AMERICA'S CUP

AC CLASS RULE

INTERPRETATION NO 10

Rule References: Rule 19.2 & ACC-3001 RevA POD LAMINATE

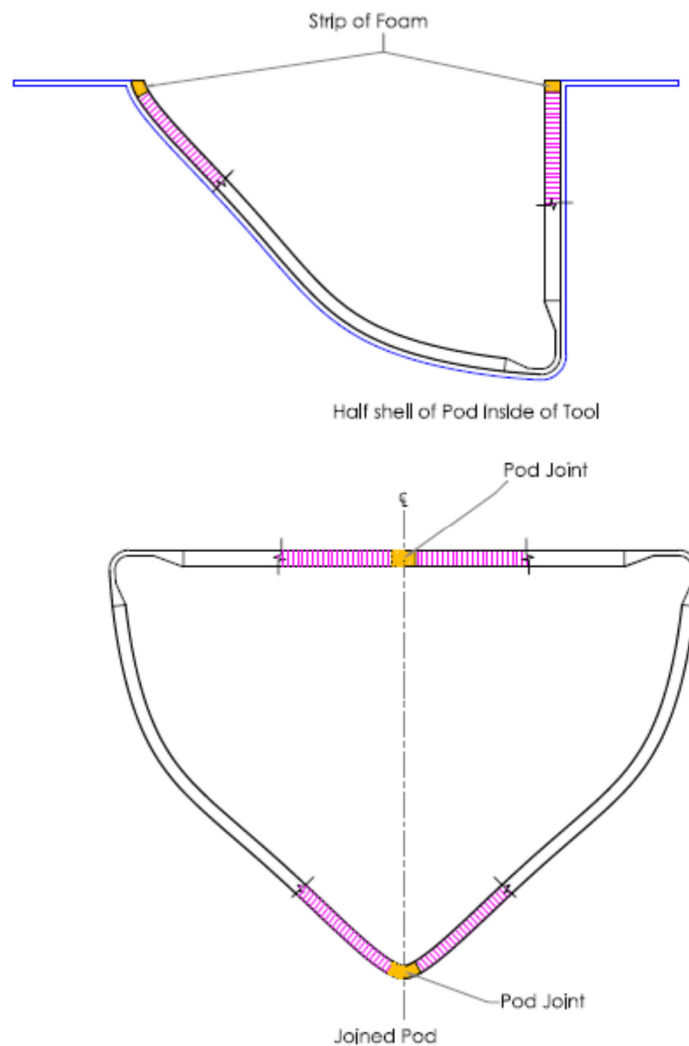
Considering Rule 19.2, will it be allowed to replace the 50kg Alloy Core by a strip of higher density Foam core to facilitate the Alloy core placement as per sketched annexed below:

The modification proposed is approved provided the replacement is only to the extent shown on the sketches and the density and thickness of the new core material is greater or equal to that of the core being replaced as specified in the drawing ACC-3001 RevA POD LAMINATE.

Attention is also drawn to Protocol 23.1 (a) and (b) related to meeting or exceeding structural specifications when considering substitute core materials. For example, shear strength, ductility and fatigue strength must be considered when choosing the core material. END
